UNITED STATES PATENT AND TRADEMARK OFFICE

APPLICATION NO.	FILING DATE	FIRST NAMED INVENTOR	ATTORNEY DOCKET NO.	CONFIRMATION NO.
10/667,602	09/23/2003	Chang-Seob Kim	61610096US	9753
58027 7590 04/05/2007 H.C. PARK & ASSOCIATES, PLC 8500 LEESBURG PIKE SUITE 7500 VIENNA, VA 22182			EXAMINER ALEJANDRO, RAYMOND	
			ART UNIT 1745	PAPER NUMBER
SHORTENED STATUTORY PERIOD OF RESPONSE			MAIL DATE	
3 MONTHS			04/05/2007	
			DELIVERY MODE PAPER

Office Action Summary

DETAILED ACTION

Figure 1 below illustrates the specific configuration of the electrode assembly:

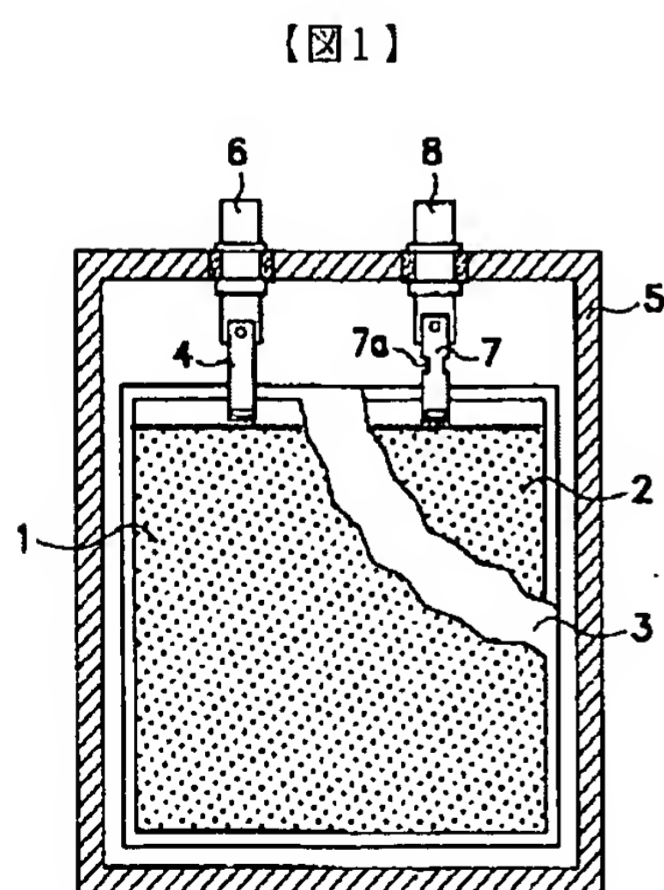
The JP'614 discloses an electrode assembly comprising a positive electrode 1 and a positive electrode lead 4; a negative electrode 2 and a negative electrode lead 7 (P. 0002/ CLAIM 1/FIGURE 1). The electrode assembly is a laminated (stacked) and wound assembly (P. 0011).

A constricted portion 7a is made at the center between an upper and lower side of the negative electrode lead 7 (ABSTRACT). Accordingly, as for the negative electrode, the constricted portion 7a sets a current limit (ABSTRACT/ P. 0014-16).

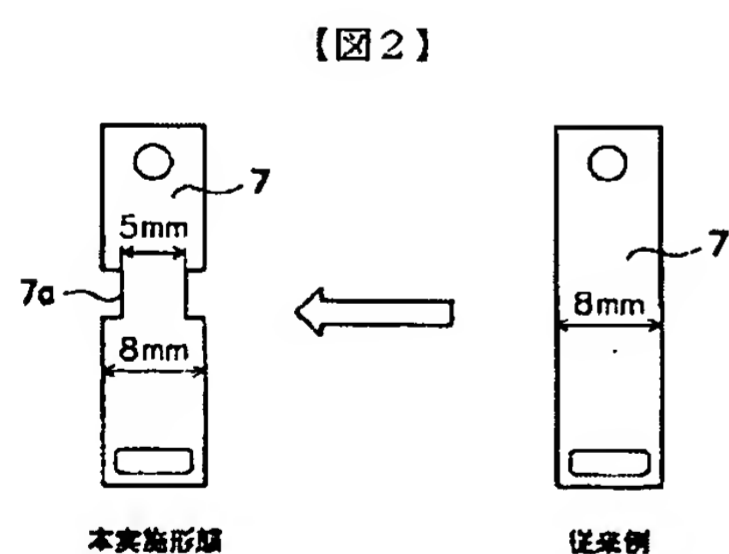
As shown in **Figure 2**, section 7a has a smaller cross-sectional area than a cross-sectional area of the negative electrode lead (See Figure 2). *As can be appreciated from the illustration of Figure 2 below, the cross-sectional area of the constricted portion 7a is smaller than the cross-sectional area of the adjacent portions.*

It is apparent from **Figure 2** above that section 7a forms a notch and/or an indentation and/or an angular cut in the edge (See Figure 2).

At least, the cross sectional area near section 7a can be represented by 5 mm x L, while the cross sectional area of the negative electrode can be represented by 8mm x L (See Figure 2). *Thus, the cross sectional area near section 7a is about 0.625 times that of the cross sectional area of the negative electrode.*

3. Applicant has now advanced the argument that the newly added limitation “*the current collector is arranged in a curved portion of the negative electrode lead*” is neither disclosed nor taught by the prior art reference. The examiner respectfully traverse this argument. For instance, Figure 2 below illustrates constricted portion 7a having at least a curved portion forming a substantially right angle on the negative electrode lead 7.
